## Memorandum

CS Memorandum No. 1309

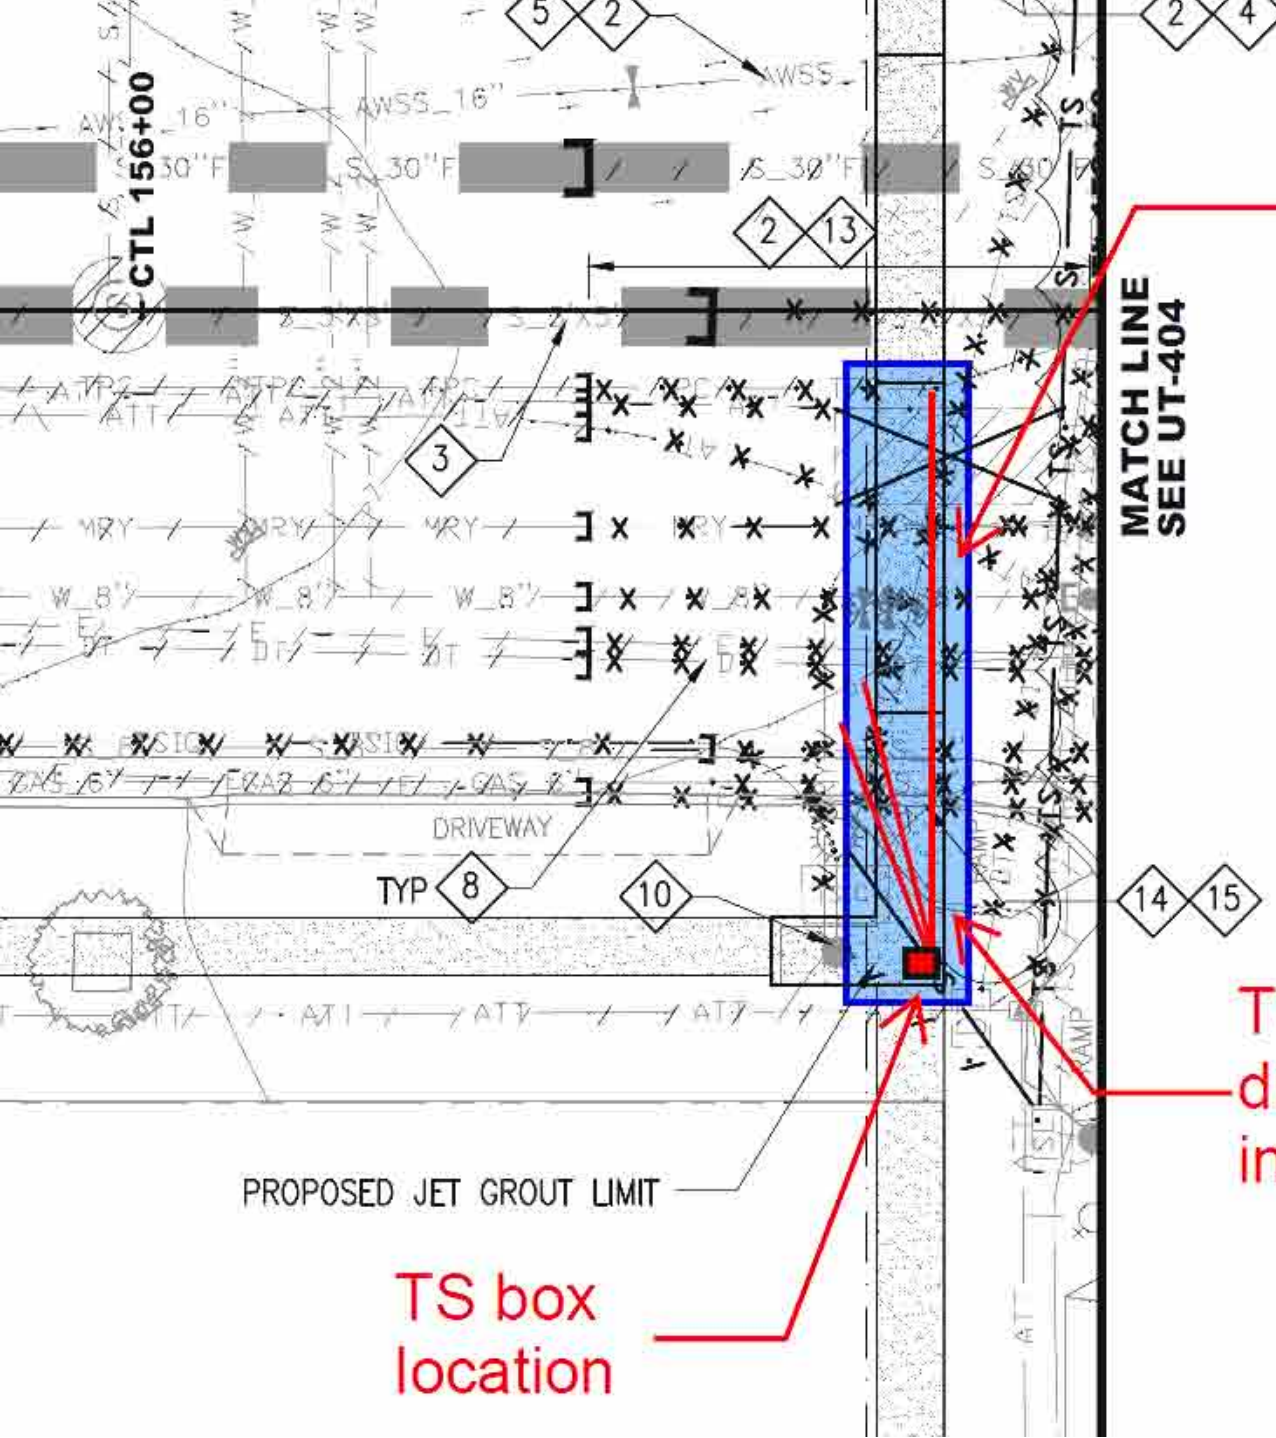
DESIGNED: M. DEFORGE DRAWN: E. MATIAS CHECKED: D. ZUJURING REVIEWED: M. CHAN RECOMMENDED: M. FOWLER APPROVED: R. EDWARDS DATE: JAN 21, 2011		REV. 0 SEALED BY M. CHAN				CITY AND COUNTY OF SAN FRANCISCO <b>MUNICIPAL TRANSPORTATION AGENCY</b>		APPROVED CARTER R. ROHAN EXECUTIVE DIRECTOR/CEO		THIRD STREET LIGHT RAIL PROGRAM PHASE 2 - CENTRAL SUBWAY TUNNELS		CONTRACT NO. <b>1252</b>	
05/04/2011 ISSUED FOR ADDENDUM 5		01/21/2011 ISSUED FOR BID		DATE DESCRIPTION		FOR ORIGINAL SIGNATURES, SEE CL-18030, REV. 0.		SCALE = 1"=10'		UTILITY DEMOLITION MOSCONE STATION CTL 154+25 TO 156+50		SFMTA CONTROL NO. <b>CL-18030</b>		DRAWING NO. <b>UD-403</b>		REVISION <b>1</b>
